February 25, 1983

Enclosed you'll find a version 2.0 ROM for your ATR8000. This ROM has added new features to the ATR8000 along with some improvements. This ROM has been shipped to you free of charge. All we ask is that you return your old ROM so that we can keep you on our Customer Update List.

New -ROM features:

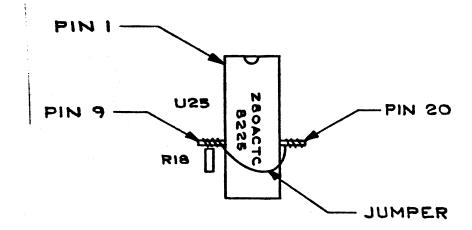
- 7) The 2.0 ROM will run flipped over disks with no index holes (we do not recommend this practice). It will also run hard sector disks that have been reformatted with a soft sector format.
- 8) We have implemented an abort timer on the CTC that eliminates possible disk controller lockup situations. To do this alteration, follow one of these two procedures. (If your unit was shipped with a 2.0 ROM, ignore this item.) We recommend the first procedure.

Locate U25 on the ATR8000 circuit board. This is the Z80A CTC, a socketed 28-pin part.

Remove the Z8OA CTC chip from the socket. This can be done by gently prying it out of the socket using a small flat blade screwdriver. The diagram below shows this chip.

Find Pins 9 and 20 on the chip. Use the diagram for reference. Bend these pins' leads straight out to the sides as shown. Using the small piece of 30 gauge wire (from SWP), connect these two pins together as shown. It

is best to solder the wire ends to the pin leads. If you do not have access to a soldering iron, then carefully wrap the ends of the wire around the leads, making several loops around each lead.

Put the chip back in the socket, making sure to replace it so that it is oriented as it was before (i.e., Pin 1 is in the proper location).
